SERVICE BULLETIN

Beechcraft

TITLE: PROPELLERS - PROPELLER SLIP RING MOUNTING PLATE INSPECTION AND REPAIR

**Installation of Hartzell 3 Blade Propeller with Goodrich Electrical Propeller Deicing
Figure 1**

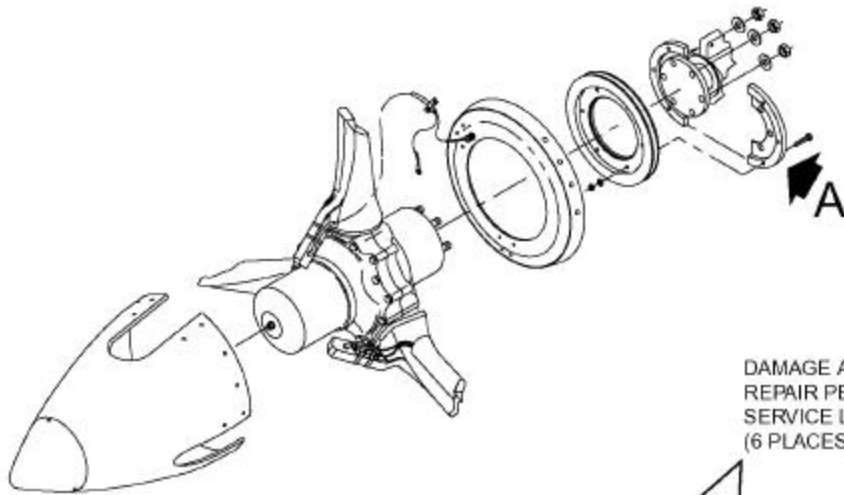
Part I of this Service Bulletin provides an initial torque inspection which checks the torque on the propeller mounting nuts to ensure that the mounting nuts are properly torqued on each propeller installation (both the left and right engines of the airplane). Refer to Figure 1. Part I of this Service Bulletin also requires the replacement of propeller hub assembly on any propeller installation that has two or more propeller mounting nuts that do not pass the initial torque inspection. Part I of this Service Bulletin must be accomplished in accordance with Hartzell Service Bulletin No. HC-SB-61-272 on each propeller installation (both the left and right engines of the airplane). After ensuring that the propeller mounting nuts are properly torqued and accomplishing the propeller hub assembly replacement (as applicable), the airplane may be returned to service until accomplishment of Part II of this Service Bulletin is required by the time limits specified under COMPLIANCE.

- (1) On each propeller installation (both the left and right engines of the airplane), accomplish Hartzell Service Bulletin No. HC-SB-61-272 to: 1) inspect the torque of the propeller mounting nuts and 2) replace the propeller hub assembly as applicable. Refer to Figure 1.
- (2) After accomplishing Hartzell Service Bulletin No. HC-SB-61-272 on each propeller installation (both the left and right engines of the airplane), make a logbook entry noting compliance with Part I of this Service Bulletin.
- (3) The airplane may be returned to service until accomplishment of Part II of this Service Bulletin is required by the time limits specified under COMPLIANCE. If Part II of this Service Bulletin is to be accomplished at a later date, proceed to COMPLETION OF INSPECTION/MODIFICATION. If Part II of this Service Bulletin is to be accomplished at this time, proceed to PART II.

Goodrich Electrical Propeller Deicing Slip Ring Split Mounting Plate
Figure 2 (Sheet 1 of 2)

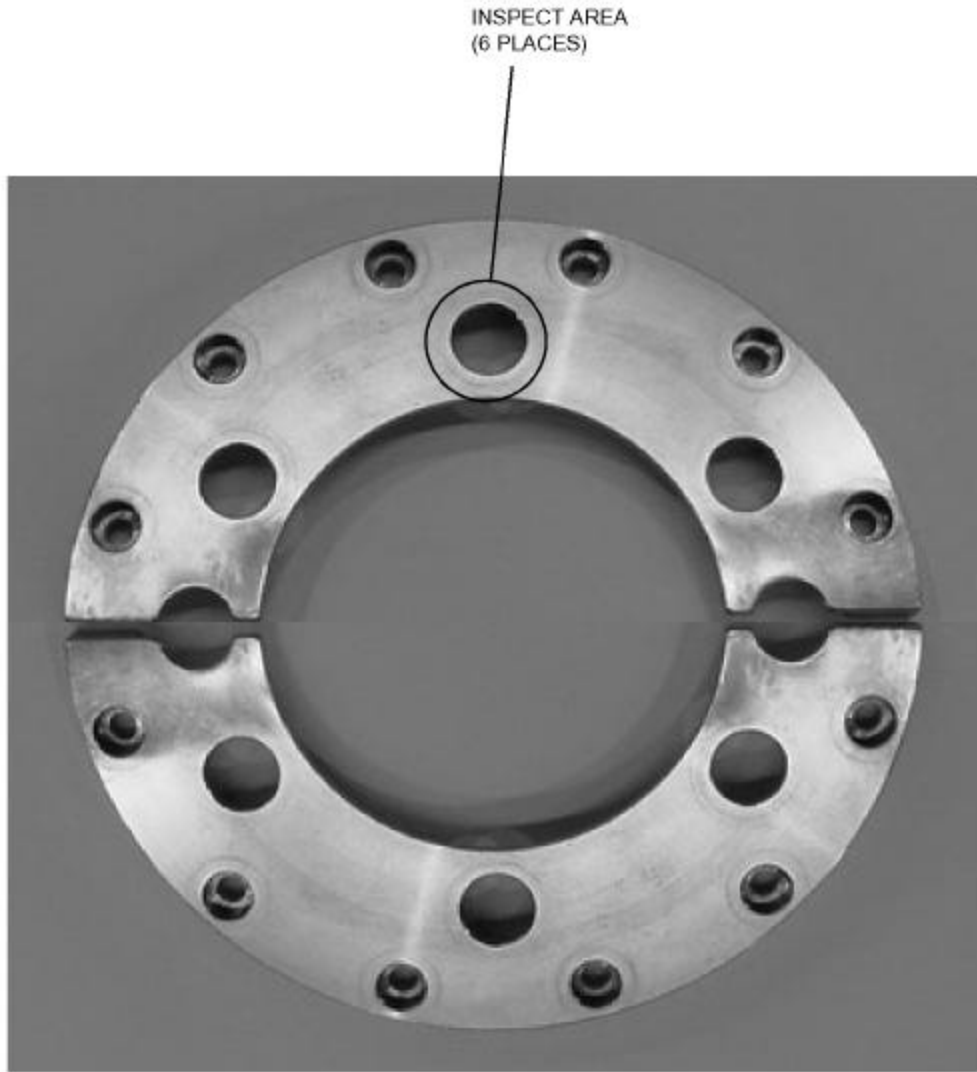
Part II of this Service Bulletin accomplishes Hartzell Service Letter No. HC-SL-61-239 on each propeller installation (both the left and right engines of the airplane) to inspect the area around the mounting hole in the propeller slip ring split mounting plate for any scoring, gouging or other damage (refer to Figures 1 and 2) that may have been caused by the propeller mounting nuts when securing the slip ring split mounting plate without the propeller mounting washers being installed. Part II of this Service Bulletin also accomplishes any applicable repairs to the propeller slip ring split mounting plate and installs a Hartzell P/N A-1381 propeller mounting washer between each propeller mounting nut and the propeller slip ring split mounting plate on both propeller installations. The propeller slip ring split mounting plate is installed on the aft side of the engine mounting flange and should be secured with a Hartzell P/N A-1381 propeller mounting washer installed between each propeller mounting nut and the propeller slip ring split mounting plate. Refer to Figure 1. A propeller slip ring split mounting plate that has surface damage around any of its mounting holes may permit the applicable propeller mounting nut(s) to lose torque and must be repaired. After inspecting the propeller slip ring split mounting plate and accomplishing any applicable repairs, ensure that the propeller slip ring split mounting plate installation has a propeller mounting washer installed between each propeller mounting nut and the propeller slip ring split mounting plate.

Any propeller slip ring split mounting plate that has surface damage around a mounting hole may permit the applicable propeller mounting nut to lose torque

- (1) On each propeller installation (both the left and right engines of the airplane), accomplish Hartzell Service Letter No. HC-SL-61-239 to: 1) inspect the area around the mounting holes in the propeller slip ring split mounting plate for any scoring, gouging or other damage that could have been caused by the propeller mounting nuts, 2) accomplish any applicable repairs to the propeller slip ring split mounting plate and 3) install a Hartzell P/N A-1381 propeller mounting washer between each propeller mounting nut and the propeller slip ring split mounting plate. Refer to Figures 1 and 2.

DAMAGE AREA
REPAIR PER HARTEZLL
SERVICE LETTER HC-SL-61-239
(6 PLACES)

and must be repaired. Remove any surface damage using a Bridgeport, or equivalent, (recommended) with a 15/16 inch counterbore piloting tool with a 0.005 inch maximum corner radius. Removal and installation of the propeller slip ring split mounting plate must be accomplished in accordance with Section 11 of the Beechcraft Baron 55 and 58 Shop Manual and the applicable Hartzell Propeller Manual(s).
